REVIEW TYPE: Minor Subdivision Record Plat and Special Protection Area
Preliminary and Final Water Quality Plan

PROJECT NAME: Islamic Society for the Washington Area
PLAT #: 220061410
REVIEW BASIS: Section 50-35A(a)(7), Montgomery County Subdivision
Regulations; and Article V (Water Quality Review in Special
Protection Areas), Montgomery County Code

PRELIMINARY & FINAL WATER QUALITY CONTROL PLAN ISLAMIC SOCIETY of the WASHINGTON AREA SILVER SPRING, MONTGOMERY COUNTY, MARYLAND

PRELIMINARY & FINAL WATER QUALITY CONTROL PLAN
ISLAMIC SOCIETY OF THE WASHINGTON AREA
COMMUNITY CENTER ADDITION
2701 BRIGGS CHANEY ROAD, SILVER SPRING, MARYLAND 20905

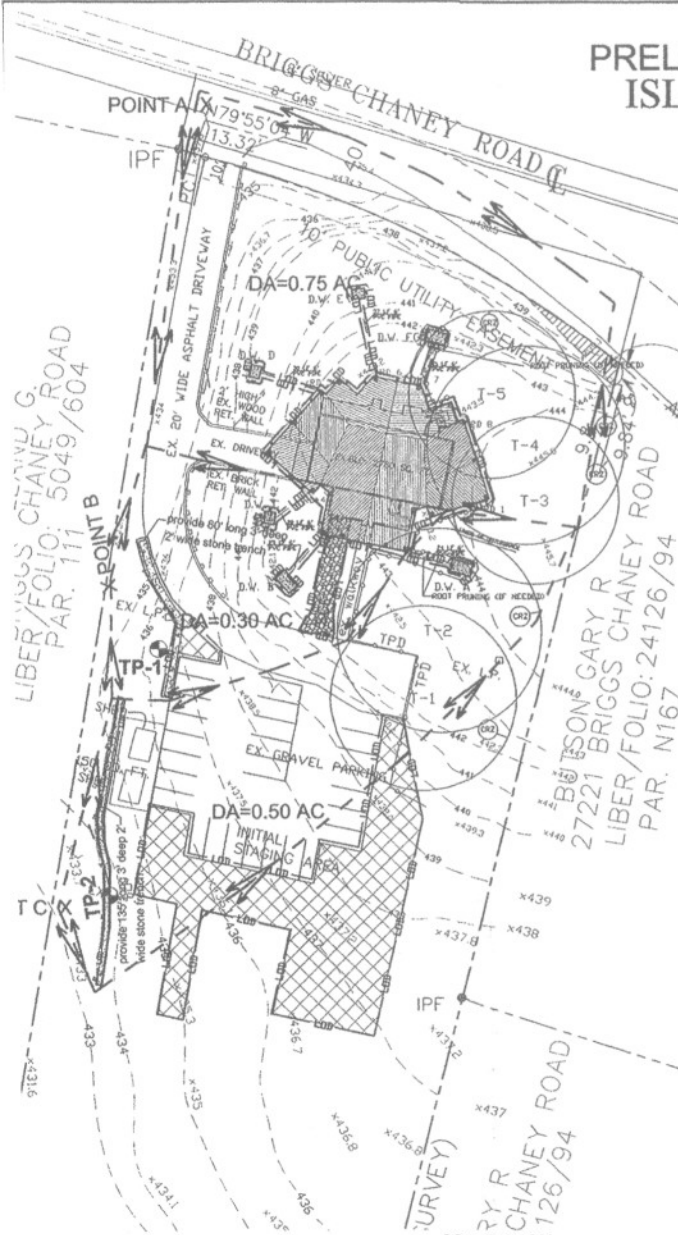
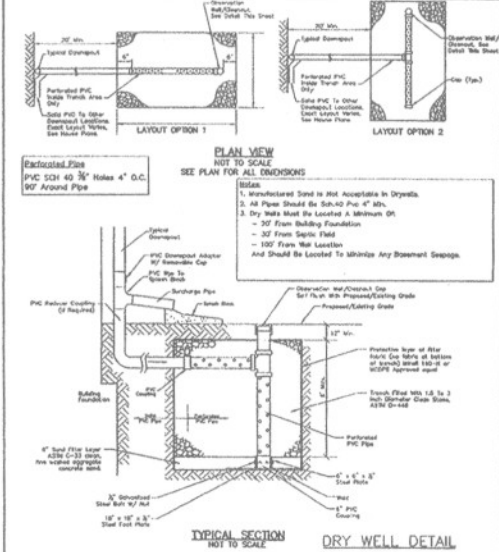
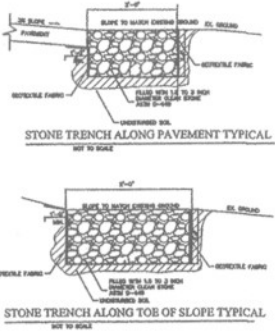
3. Category I conservation easement must be placed over the environmental buffer area. Conservation easement must be shown on the record plat.
4. Applicant must revise the tree save plan to show tree protection fencing along the limits of disturbance that are within the critical root zones of five trees that are located on the northeastern part of the property and that are greater than 24 inches in diameter at breast height. The tree save plan must also show tree protection signs and 14 gauge, 2 inch x 4 inch welded wire fencing supported by steel T-bar posts (minimum 4 feet high) with high visibility flagging for tree protection fencing.

disturbance are acceptable, but the plan must include tree protection fencing and signage along the limits of disturbance that are within the critical root zones of these trees. The forest conservation exemption plan also notes that the bamboo that grows within the environmental buffer will be removed and native trees will be planted to replace the bamboo.

1. The boundary is wrong.
2. My address is wrong.
3. There are no parking spaces shown on the plan.
4. There is no building square footage, thus no parking impervious calculation.
5. The impervious area is not calculated.
6. No sewer is shown.
7. Briggs Chaney Road is not shown correctly.
8. The trench shown between trees 4 & 5 will cut off half of the root system. These are large specimen oak tree's important to the neighborhood & must be saved.
9. The building is expanded to cut off much of the root system of trees 3,4, & 5.

10. No setbacks are shown.
11. The driveway entrance is too narrow, must be a commercial entrance.
12. The impervious area is too high. My subdivision next to this property was limited to 8.9%. Why do they propose 10%? Can I get 10%?
13. There is no landscape or lighting plan provided.
14. Is there a reforestation plan and does it require bamboo removal & bonding.
15. The property does not have a plat now & newer has. The letter by Richard Brush is wrong. There is no lot.
16. The plan says there is 22,310s.f. impervious area. Please have them show all impervious area on the plan, including parking.
17. They sent me sheet 1 of 4, I need all the sheets, 1, 2, 3 & 4.
